Endeavour Energy 2024 to 2029 Regulatory Proposal

REVIEW OF PROPOSED EXPENDITURE ON DER AND NON-RECURRENT ICT

Report prepared for:
**AUSTRALIAN ENERGY
REGULATOR**
August 2023

Figure 3.1: Endeavour Energy’s hosting capacity model – inputs processing and outputs

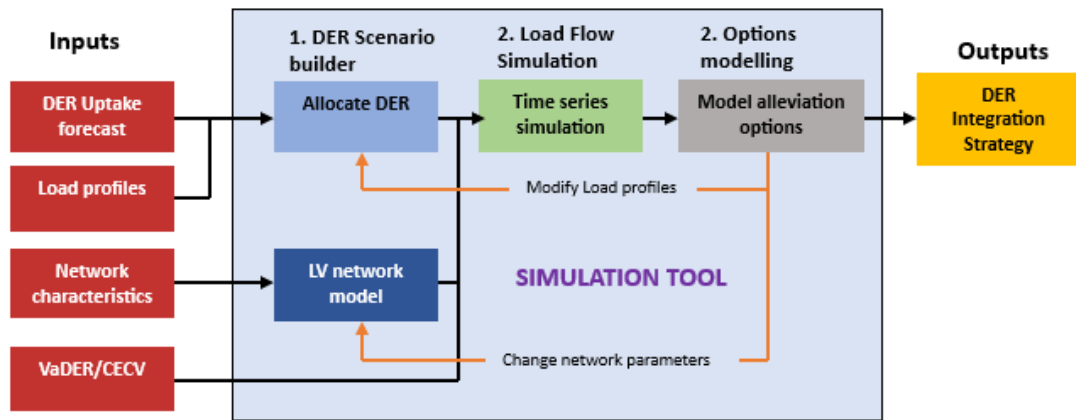
66. Figure 3.1 illustrates Endeavour Energy's hosting capacity simulation tool, referred to as the hosting capacity model (HCM). We assess Endeavour Energy's approach to building the four stages of the HCM below.
67. In this section we focus on assessment of the suitability of the model in determining the curtailment energy, focusing on the inputs and parts 1-3 of the Simulation Tool. In section

Figure 3.2: Step Change Scenario forecast DER penetration as % of customers on Endeavour Energy network

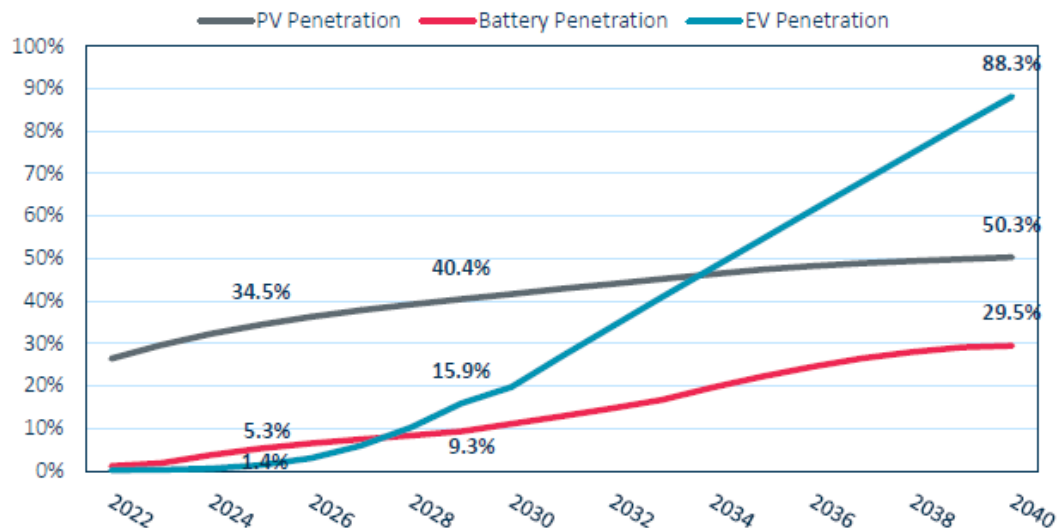
74. Endeavour Energy has applied the ISP Step Change Scenario to forecast DER penetration for PV, EV, and Batteries through to 2040, as shown in the figure below. We consider that:

- Endeavour Energy has applied the AER-recommended AEMO ISP Step Change Scenario per its DER integration guidance note;²⁰
- Other sources (referenced in Endeavour Energy's HCM description), are adequate for modelling purposes;
- It is reasonable to expect that with falling technology costs, national support for DER as a plank of energy sector transition to lower GHG emissions, and the increasing cost of grid-delivered electricity, that DER penetration will continue to grow; and
- Based on the information provided, it is reasonable for Endeavour Energy to assume that residential inverter sizes will continue to grow for at least the next few years towards the (current) 10kW installed capacity cap.

Figure 3.6: Endeavour Energy’s assumed impact of tariff reform on behavioural change

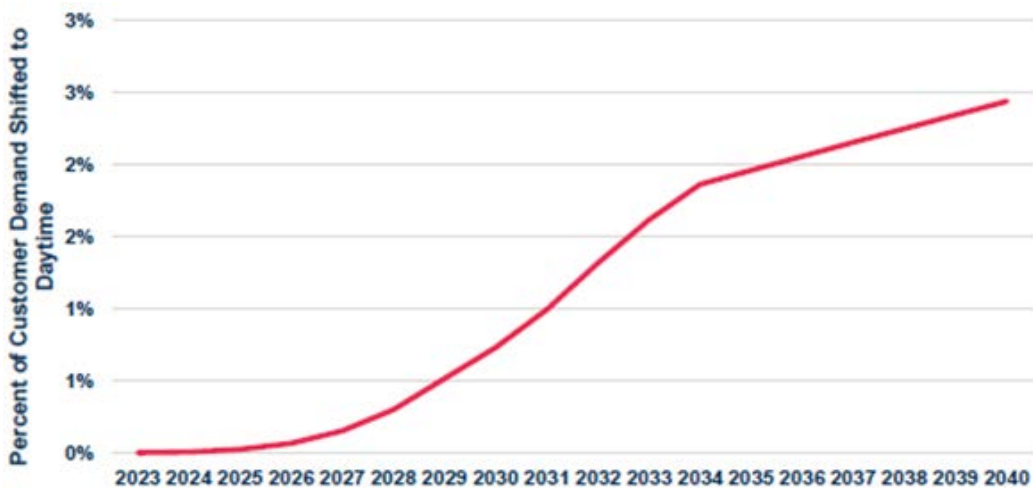
- 105. Endeavour Energy’s assumed behavioural change in response to non-DER tariff reform is illustrated in the figure below where Endeavour Energy assumes that there will be essentially an insignificant contribution to managing solar impacts.

- 106. Whilst dynamic pricing would be unlikely to have a major impact within the next five years, it shows promise as a means of increasing hosting capacity and therefore reducing curtailment energy (all other things being equal) in the medium term and onwards.

Figure 3.8: Endeavour Energy's assessment of forecast modelled curtailment value per annum post intervention

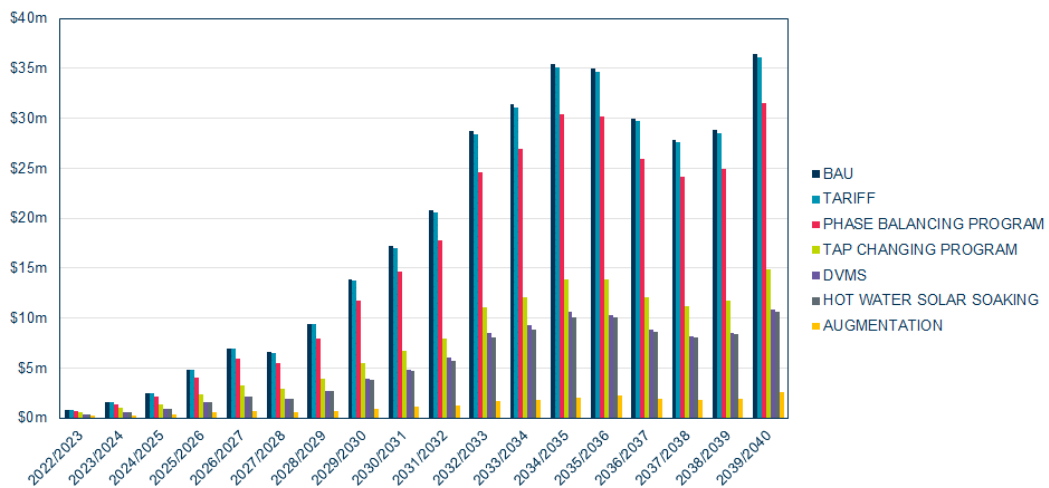
137. In Figure 3.8 we have reproduced Endeavour Energy's presentation of the costs of customer curtailment with no intervention (BAU) and with the progressively introduced interventions listed above. Endeavour Energy's analysis is that tariffs would provide minimal reduction, while the largest reductions in curtailment tap changing, augmentation and phase balancing.

Figure 3.9: Proposed DER benefits, costs and net benefits (as presented by Endeavour Energy)

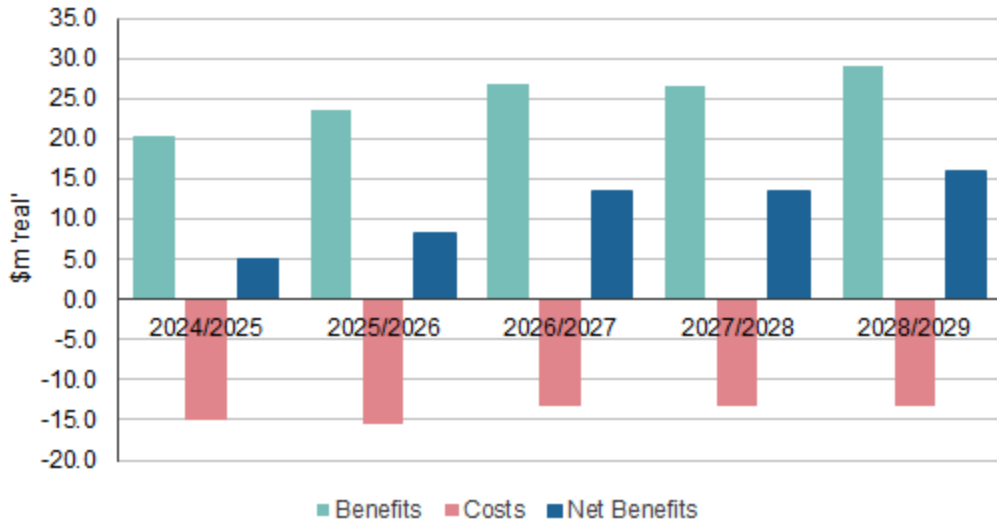
However, the benefits ascribed to each year in the regulatory period comprise a mixture of benefits assessed as being realised in those years and NPVs of future benefits.

- 143. Further, we observe that costs beyond the regulatory period are not considered in the ‘NPV’ analysis.
- 144. Endeavour’s ‘NPV’ results are as shown in Figure 3.9. However, due to the modelling flaws referred to above we conclude that the CBA model does not contain any valid representation of the annual benefits or net benefits in the next regulatory period, nor of the NPV of the proposed DER program nor of any element of that proposed program.

Figure 3.10: Justifiable capex project count per year forecast RCP 24-29

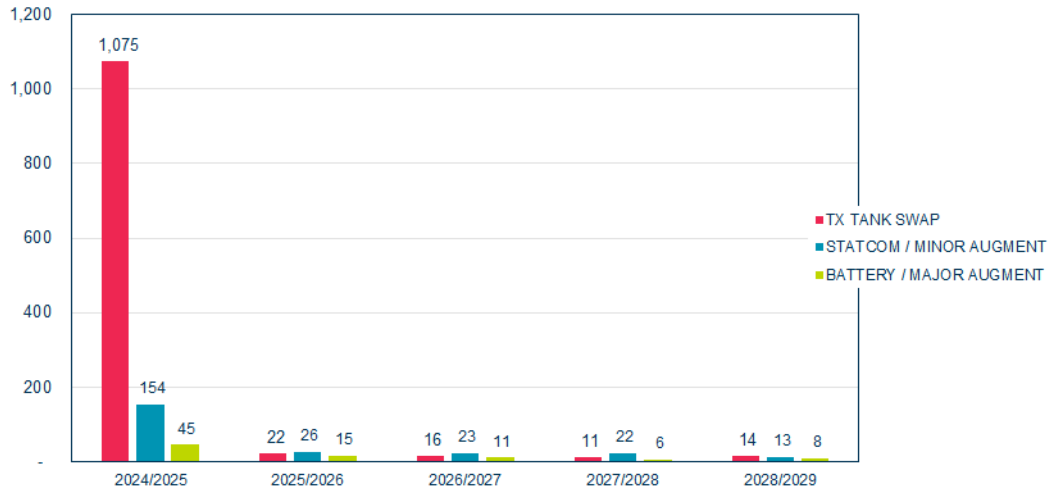
- 147. Secondly, the model incorporates flawed logic on the optimum timing to undertake works that are determined on the basis of their economic value. Specifically, the first year in which a positive NPV is achieved is not necessarily the optimum (from an economic perspective) and it is typically the case that the NPV is higher if the investment is deferred. The optimum timing (as represented by the highest NPV) is defined by the year in which the annual benefits exceed the annuitised costs.

148. Unsurprisingly, the Endeavour model schedules the distribution substation augmentation almost entirely in the first year of the period, implying (incorrectly) that it should have already been undertaken. The 'raw' analysis from Endeavour's model is shown in Figure 3.10.³⁹

Figure 3.11: Indicative annual expenditure on distribution substation solutions if timing optimisation is correctly applied

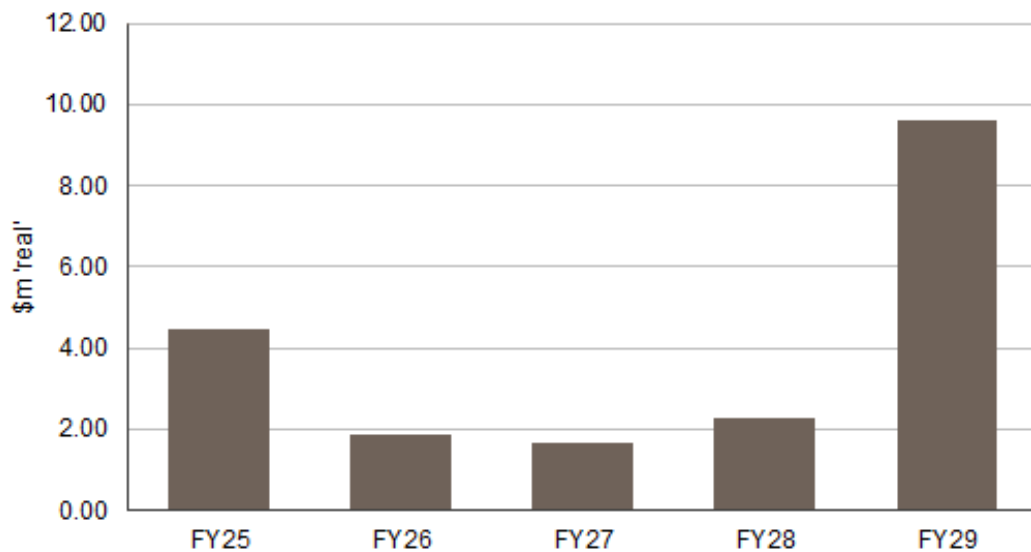
149. We made some indicative modifications to test the extent to which Endeavour's method 'front loads' and overstates the economically justifiable expenditure. As shown below, a correct application of the economic test removes the front-loading of the 'justifiable' expenditure and even the raw results from modelling (which could be smoothed to provide for an operationally preferable program of work) are more evenly spread. The resulting justifiable level of augmentation is also lower, at just under \$20m, compared with \$29m in Endeavour's model (and which is therefore included in its proposed \$45m DER capex).

Figure 3.12: Average DER customer curtailment experience (% of System Output)

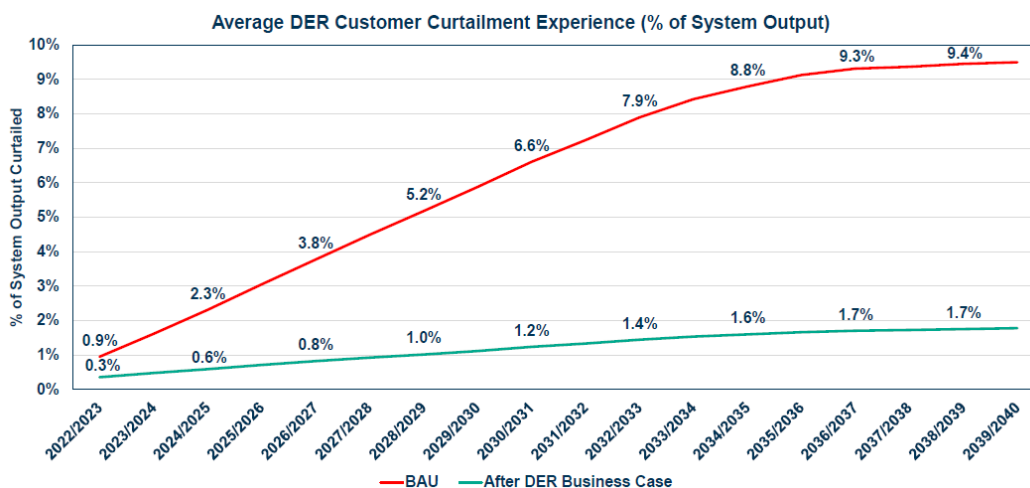
- Endeavour’s DERMS benefit calculation also assumes hard coded ‘*percentages of time curtailed by DoE*’ of 1% in 2024/25 and rising annually to 5% by 2028/29. None of the calculations of avoided curtailment in the DERMS benefits calculations appear to be consistent with those shown in Endeavour Energy’s business case, as shown in Figure 3.12.

Figure 4.7: Endeavour Energy’s identified sources of benefits for Investment Brief #2
Measures of benefit

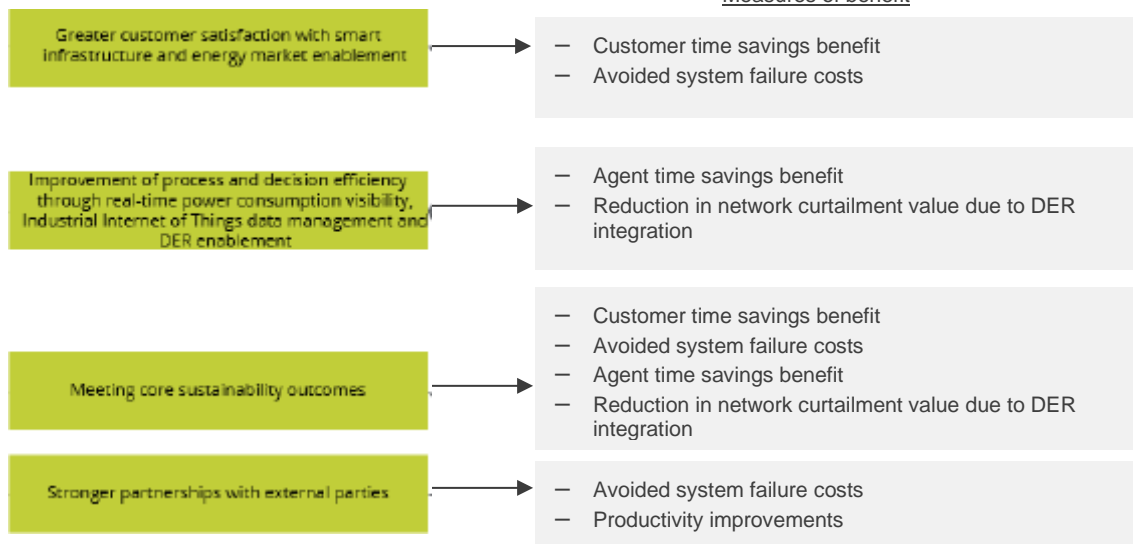
- 247. Whilst most of the benefits from non-recurrent expenditure allocated to projects in this Investment Brief from the sources listed in Figure 4.7 can reasonably be expected to be generated from these projects. For example, Project 148 – Operations orchestration, automation and workflows - is likely to contribute to productivity improvement.
- 248. However, Project 150 (Application performance testing and testing automation tools) is linked to benefits from avoided system (network) failure costs. The link is not obvious from the information provided.

Figure 4.9: Endeavour’s identified sources of benefits for Investment Brief #3 (non-cyber-security related)

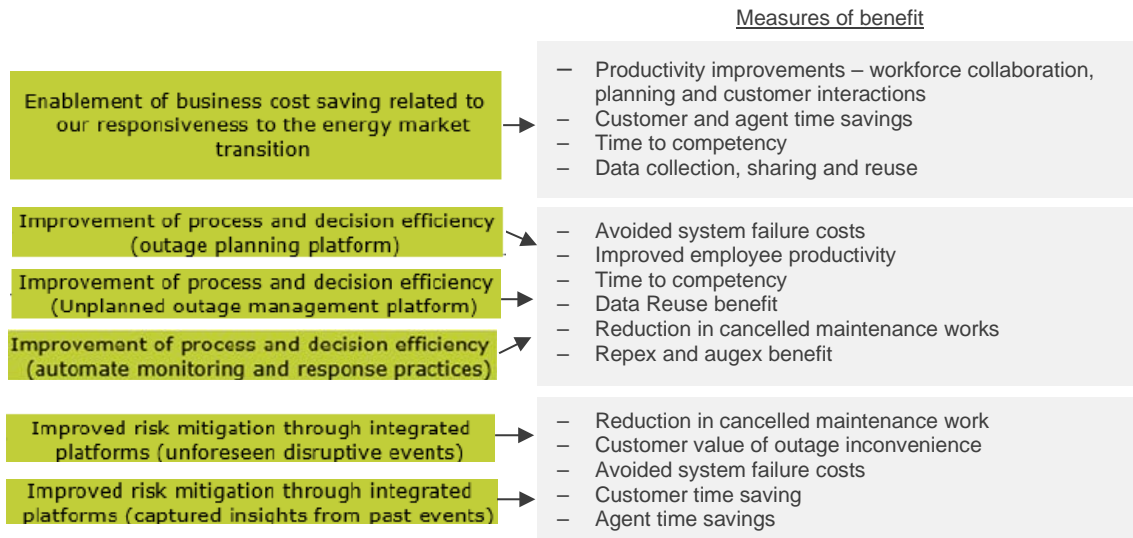
- 266. Most of the benefits from non-recurrent expenditure allocated to projects in this Investment Brief from the sources listed in Figure 4.9 can reasonably be expected to be generated from these projects.
- 267. However, Project 48 (Federated records management, enterprise search and secure sharing (ongoing)) which involves ‘*design and governance of practices for integrated and easy to use federated records management systems, enterprise searchable records (current*
